YANKEE ATOMIC ELECTRIC COMPANY

Subject: Yankee Decommissioning Quality Assurance Program Periodic Update Submittal

YDQAP CR 03-03

YDQAP Summary of Changes - Revision 31

The lines of authority for personnel and functional positions involved in the implementation of the YDQAP are shown in Figure 1.

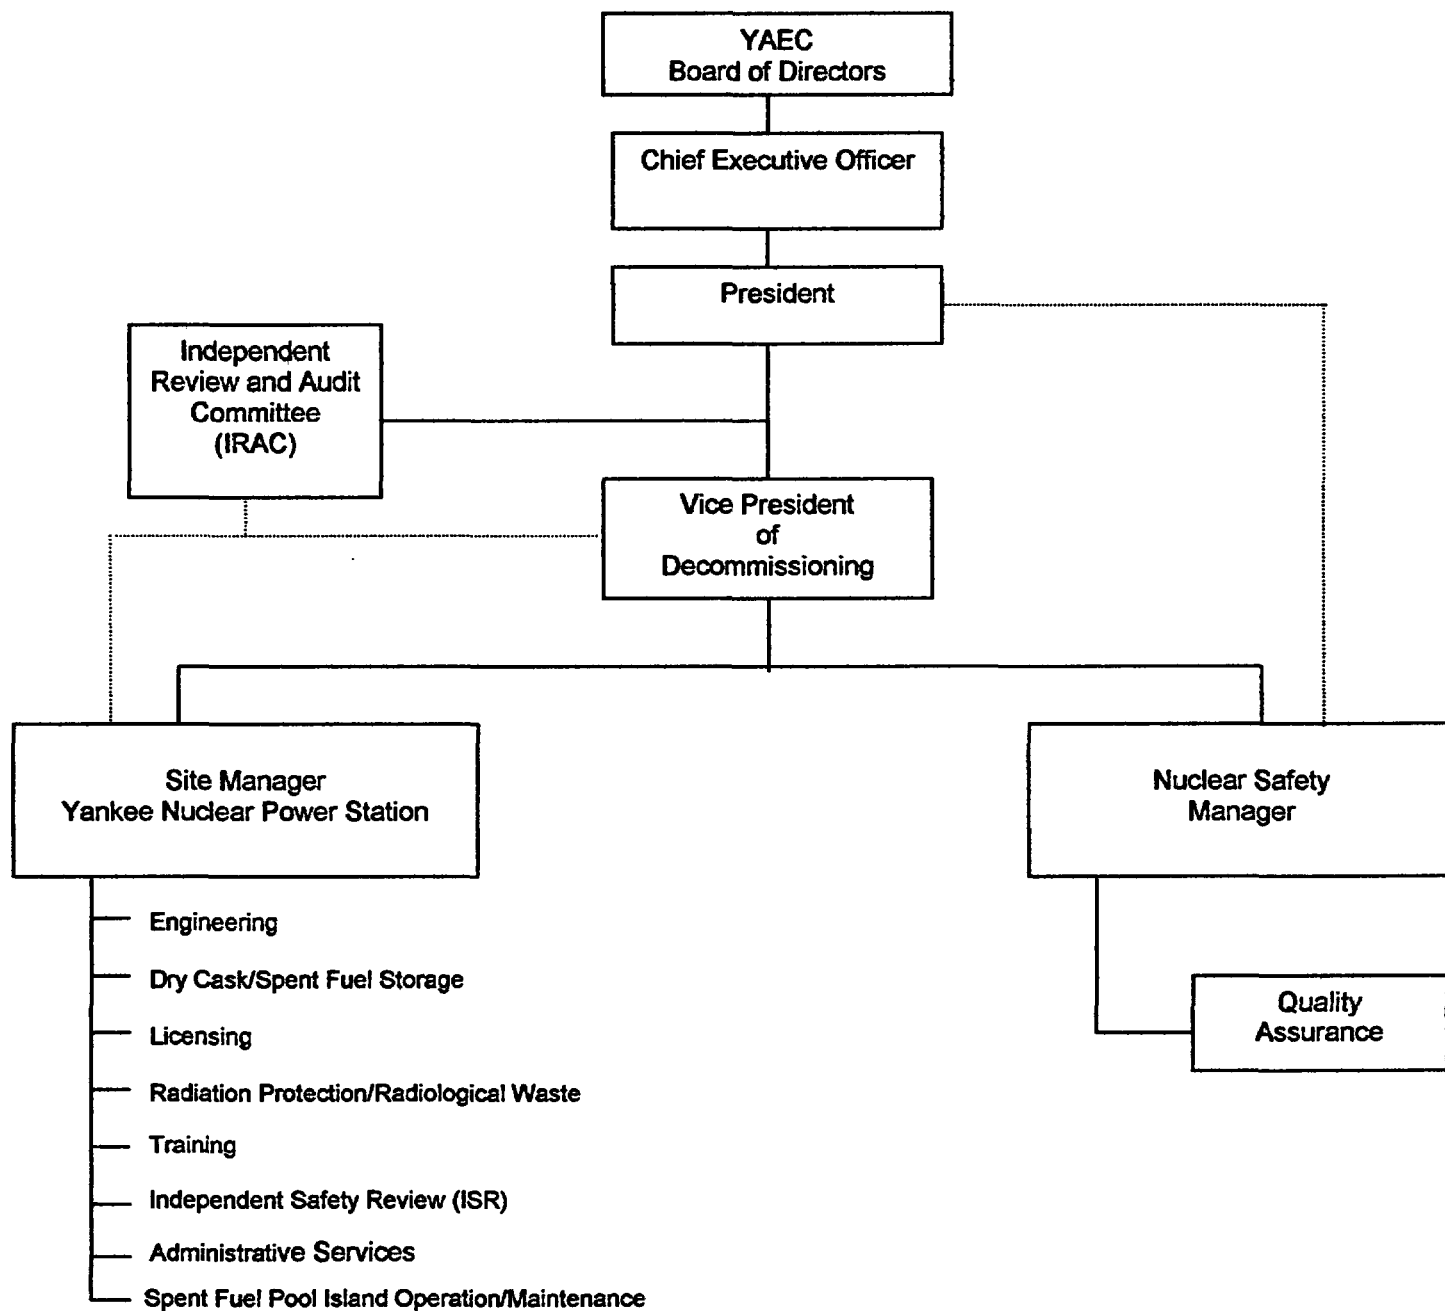
4.	Section I	Redistributed the responsibilities of the singular position of "CEO and President" to two positions titled; 1) "CEO" and 2) "President" and updated reporting lines as necessary in position descriptions and Figure 1 "YAEC Organization". Change evaluated under CR 03-01.	YAEC Organizational Change
